CONTRACT CHANGE ORDER NO. 42
SHEET ____ OF ____

DETAILS
SAS SUPERSTRUCTURE ROADWAY EASTBOUND CONDUIT LOCATIONS
SCALE AS NOTED

E-162

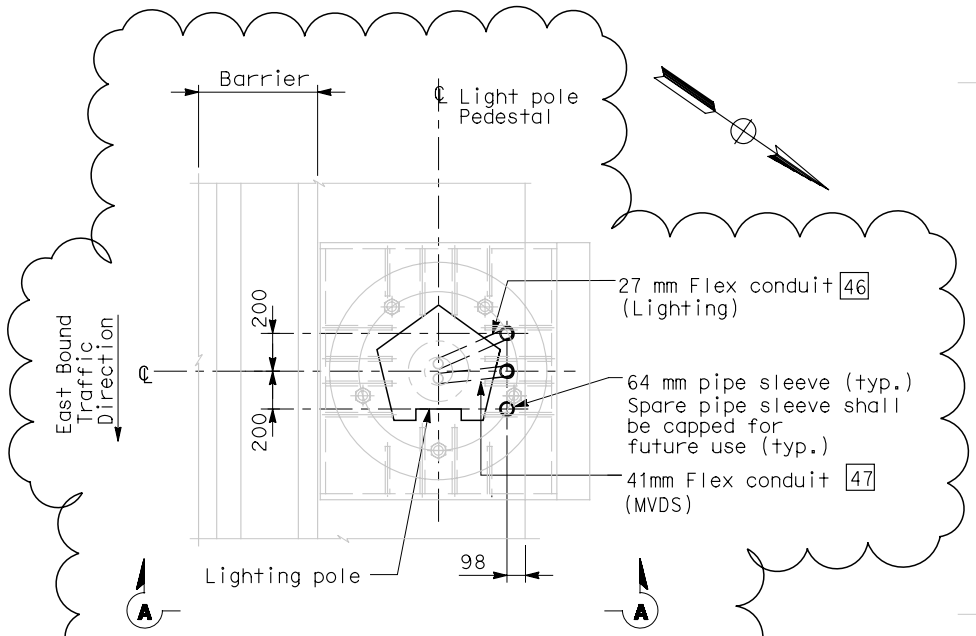
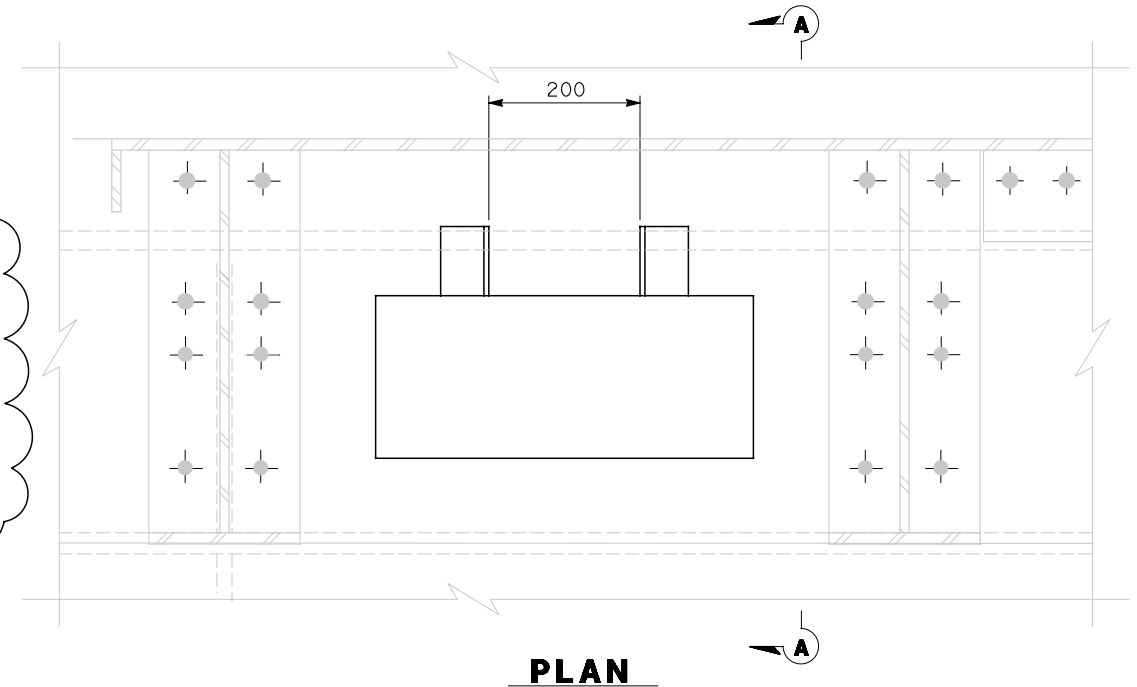
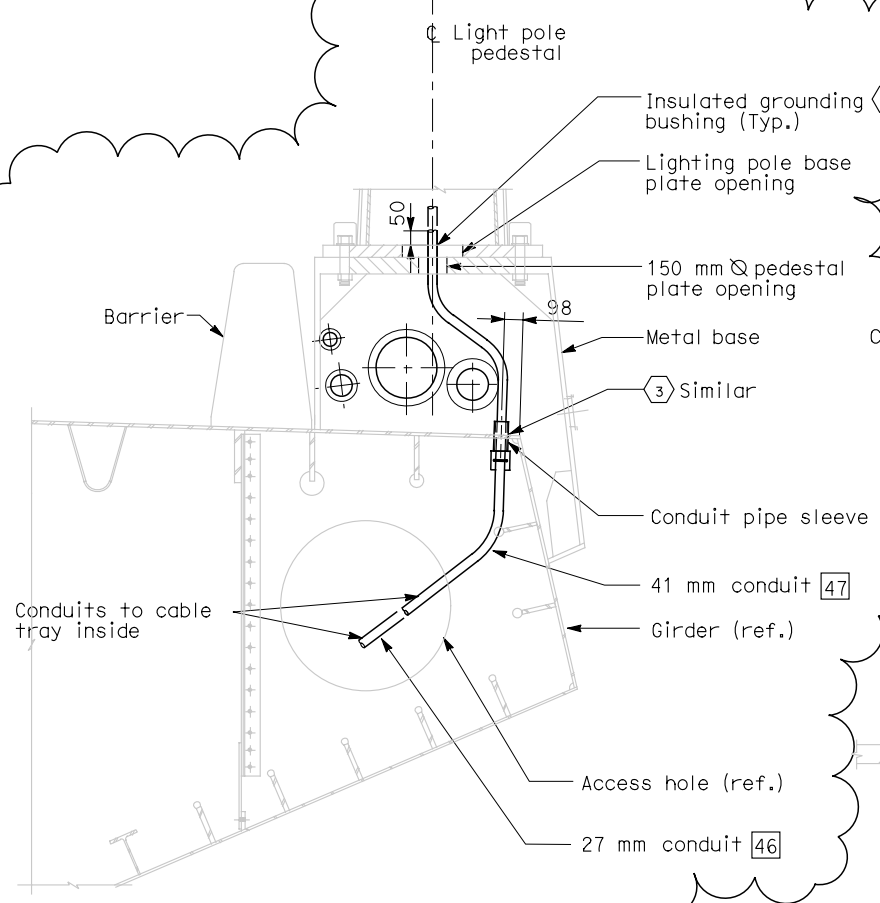
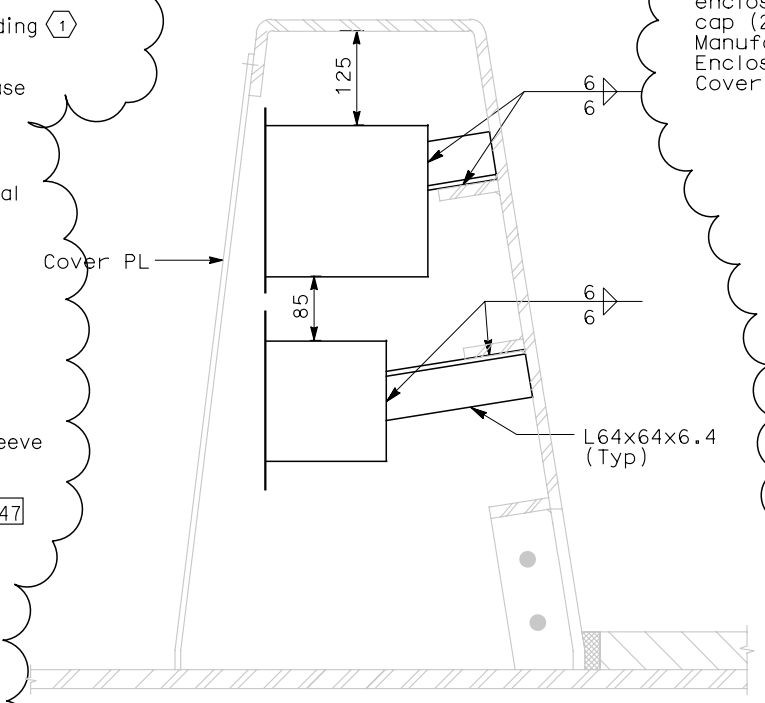
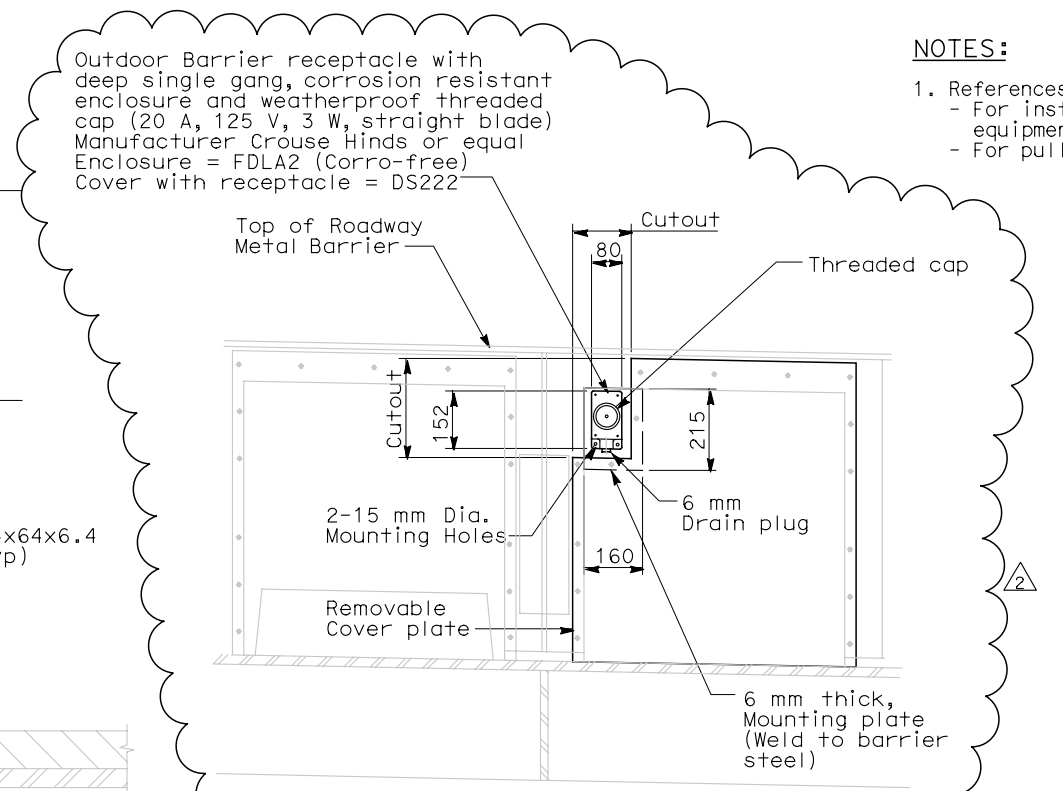
MARK	DATE	DESCRIPTIONS	BY	CK	CCO
2	08-06-07	Electrical modifications.	MP EL RG	RR	42
1	10-16-06	Revised sheet notes.	LR	MG	11

1. Bond grounding bushing to ground lug of lighting pole with #6 bare copper wire.
2. Deleted
3. See Utility Detail No. 1 (See Sheet No. 965 of 1204) for conduit penetration through girder plate and lighting pole metal base. The contractor shall install sealant between the sleeve and conduit to prevent water or moisture from passing inside the sleeve.
